Re: Clinton Landfill #3
TSCA Permit Application

KPRG Project No: 10110

KPRG's project team performed a technical review of the geologic and hydrogeologic portions of applications filed for the Clinton Landfill No. 3 expansion in DeWitt County, Illinois. This review focused on the application for a chemical waste disposal facility within the footprint and airspace of the proposed expansion of the Landfill No. 3 facility. Our review has identified several issues that should be of concern to, and be considered by, the United States Environmental Protection Agency (USEPA) in reviewing the pending application. The following sections describe the proposed site and landfill characteristics, and detail concerns identified in our review.

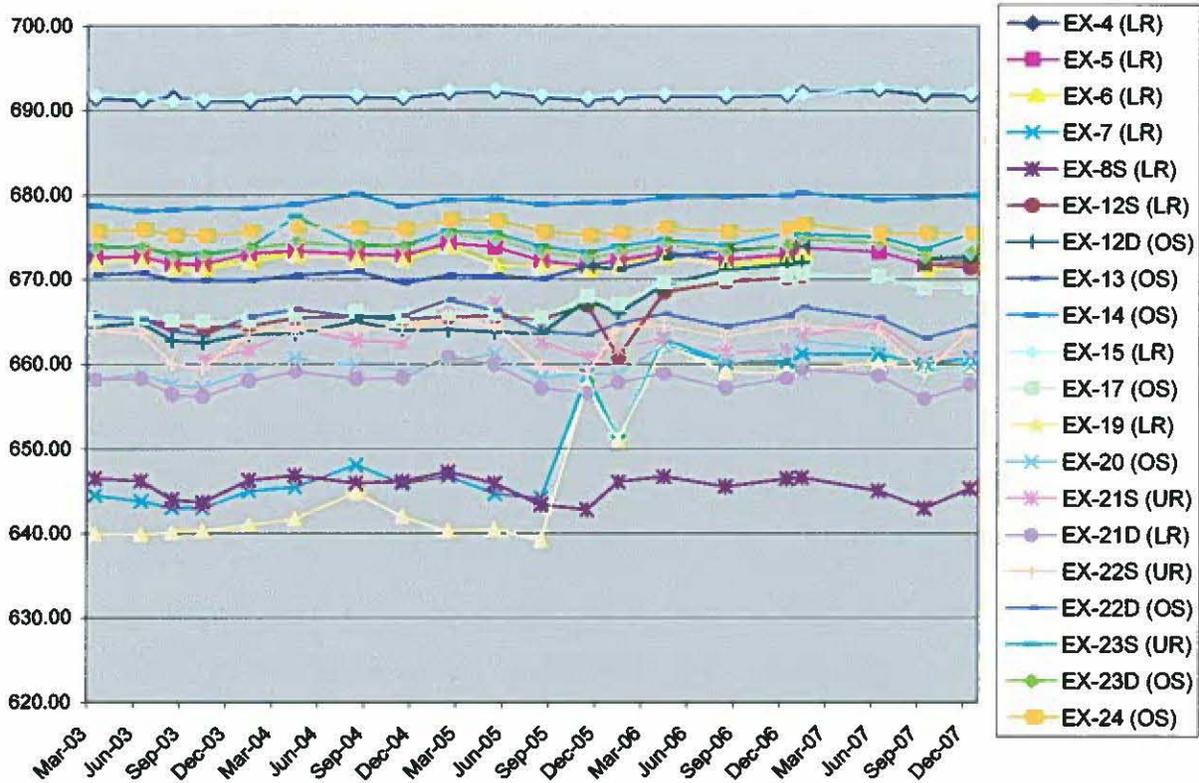
- **Insufficient Evaluation of Head Data** - Review of the groundwater head data supplied with permit application (see graph of heads below) shows that all monitoring wells located along the west and northwest boundaries of the Clinton Landfill (e.g., wells EX-7, EX-12S, EX12-D, EX-13, EX-17, and EX-19) for which head data was reported experienced rapidly rising heads commencing in late 2005 and 2006 while the remaining monitoring wells remained nearly static. This is an unusual occurrence that is completely unaddressed in the permit application.

To identify the cause of the increase in heads, readily available aerial photographs of the site were reviewed. It was observed that what appear to be storm water retention ponds, associated with construction on adjacent portions of the Clinton Landfill, had been constructed near the west and north perimeters of the permit area. If these ponds are the source of water causing the localized rise in heads, the glacial sediments when the proposed Chemical Waste Unit are capable of readily transmitting groundwater in a flow system that is significantly different than that described in the permit application. This casts doubt on the entire site characterization and resulting GIA in the Landfill application.
